MONTAGUE STREET
REVIEW OF POD ROOMS
GROUND FLOOR
ATELIERDB 25.10.2024

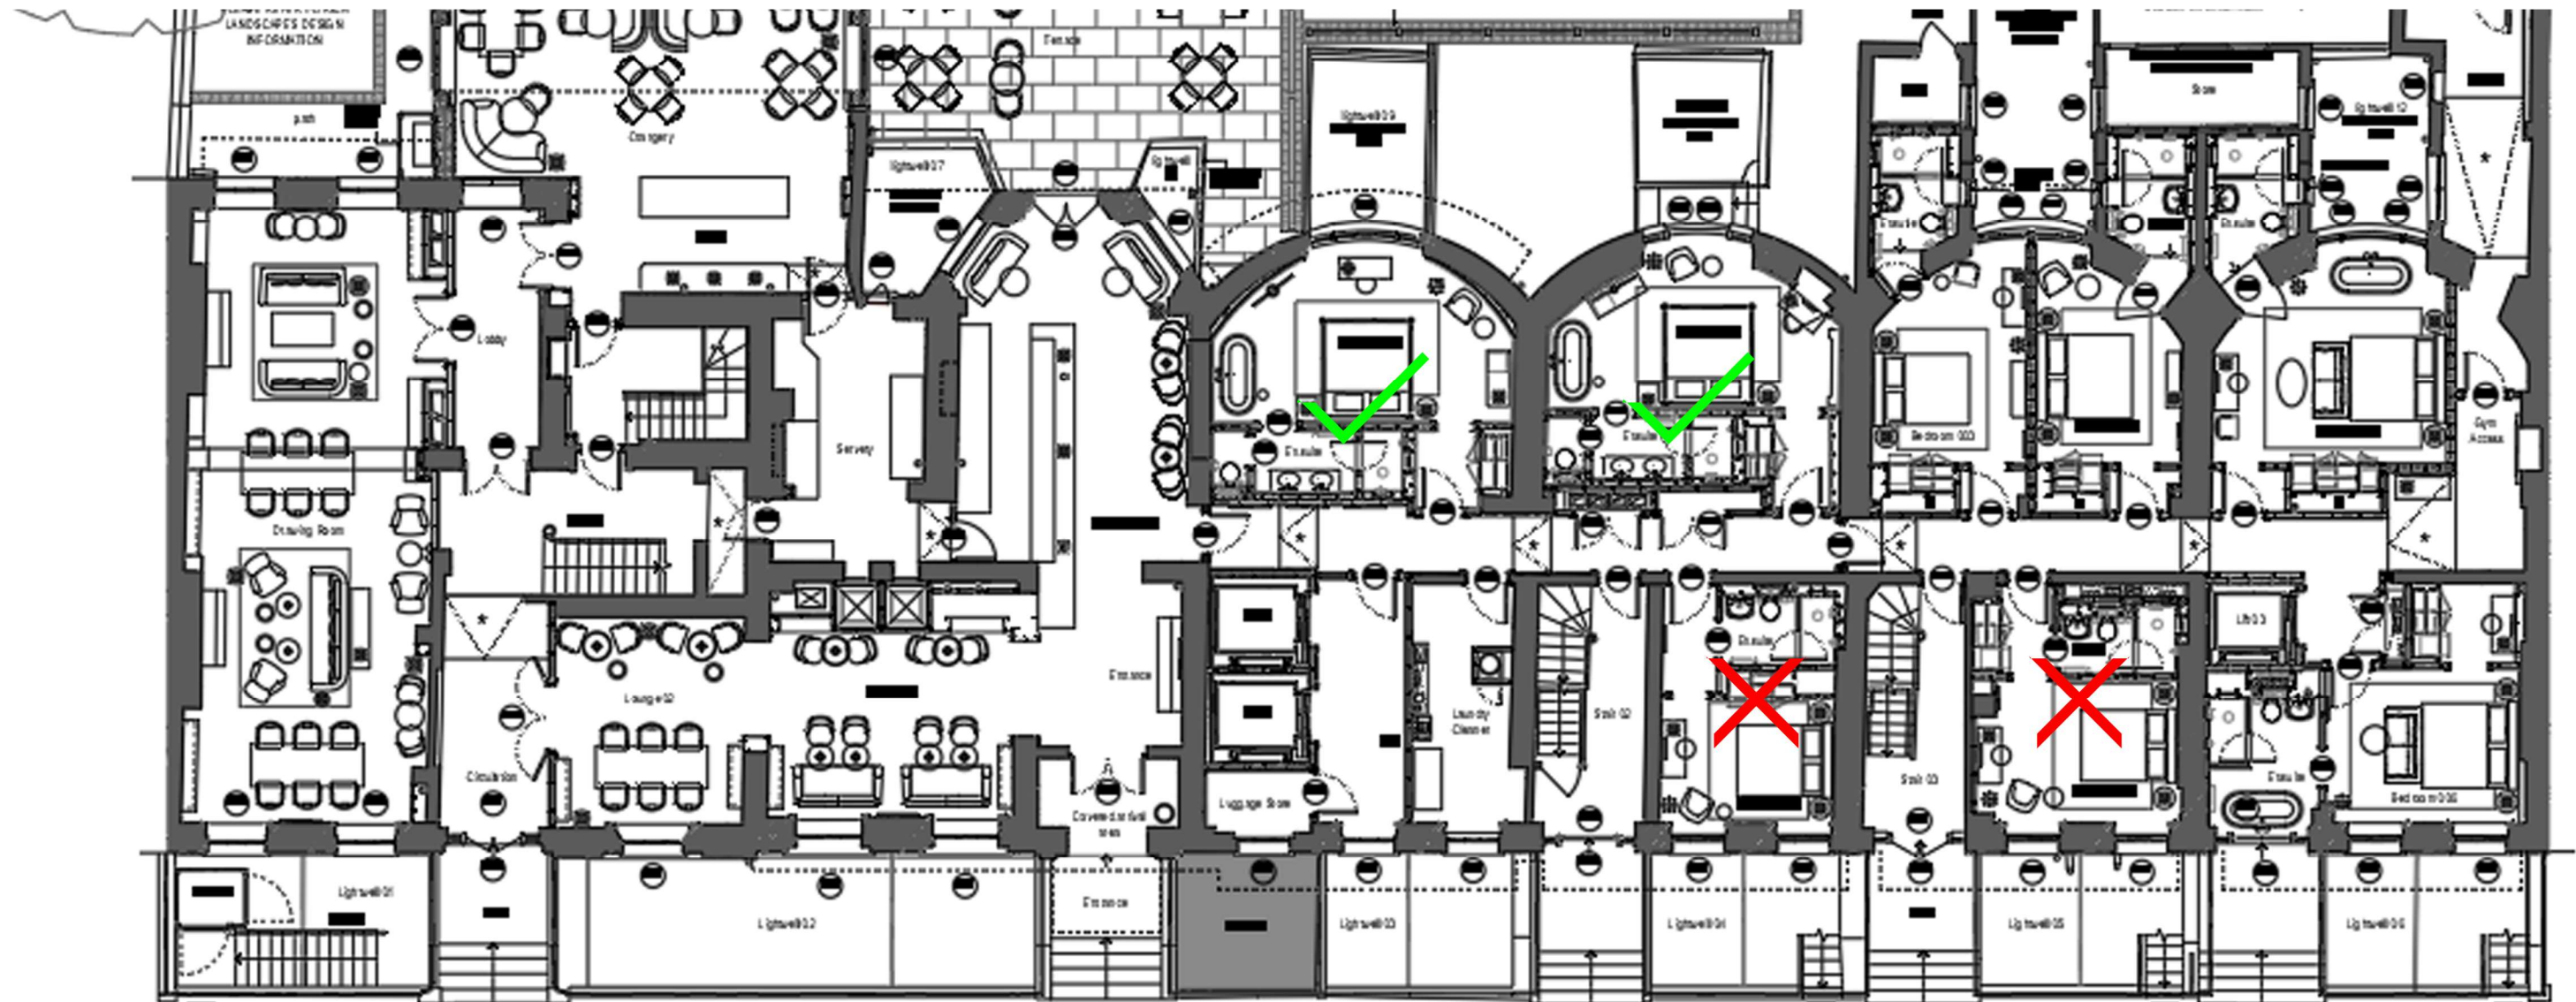
due to remaining historic ceiling and cornice, and requirement to achieve compliance with Part B of Building Regs, a new fire compartment ceiling has to be installed at a height below the retained coving - negating a meaningful gap above the bathroom pod as can be achieved in the pod rooms at the rear of Buildings 4 and 5.
